Access Compliance Report

Public Rights-of-Way

Intersection ID: 27889	Main Street: ELROSE_PL	Cross Street: GANDER_DR	Location:	N
ADA ID: 3D7C6EA9A76D	Ramp Type: Perp	Initial Pass/Fail: Fail	Overall Compliance: No	Severity Score: 10
Codes/Mitigation Info/Possible Solution		Field Measurements/Component Compliance

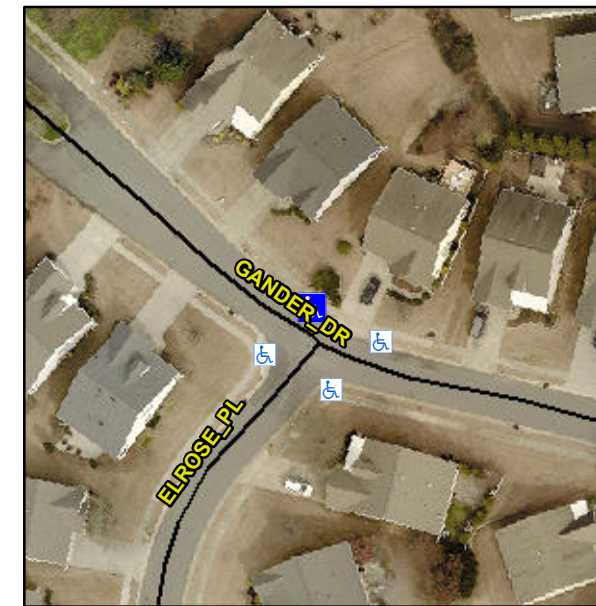
Not Found, R304.5.1, R304.5.3

Compliance	Description	Data	Compliance	Description	Data
N/A	Ramp Length (in)	45.0	Yes	Ramp Slope (%)	8.1
No	Ramp Width (in)	45.0	No	Ramp XSlope (%)	4.4
N/A	Flare Type LT	N/A	N/A	Flare Type RT	N/A
N/A	Flare Slope LT (%)	N/A	N/A	Flare Slope RT (%)	N/A
N/A	Flare Traversable LT?	N/A	N/A	Flare Traversable RT?	N/A
N/A	Landing Length (in)	N/A	N/A	DWS Provided?	N/A
N/A	Landing Width (in)	N/A	N/A	DWS Contrast?	N/A
N/A	Landing Slope (%)	N/A	N/A	DWS Length (in)	N/A
N/A	Landing X Slope (%)	N/A	N/A	DWS Full Width?	N/A
N/A	Landing Curb? (Y/N)	N/A	N/A	DWS Offset (in)	N/A
N/A	Shared Landing?	N/A			
N/A	Gutter Ponding?	N/A	N/A	Gutter Slope (%)	N/A
N/A	Gutter Lip Ht (in)	N/A	N/A	Gutter X Slope (%)	N/A
N/A	Painted X Walk1?	No	N/A	Painted X Walk2?	N/A
	X Walk 1 Direction	To SW		X Walk 2 Direction	N/A
N/A	X Walk 1 Width (in)	N/A	N/A	X Walk 2 Width (in)	N/A
	X Walk 1 Slope (%)	2.9		X Walk 2 Slope (%)	N/A
	X Walk 1 X Slope (%)	3.9		X Walk 2 X Slope (%)	N/A

Remove & Replace Entire Ramp.
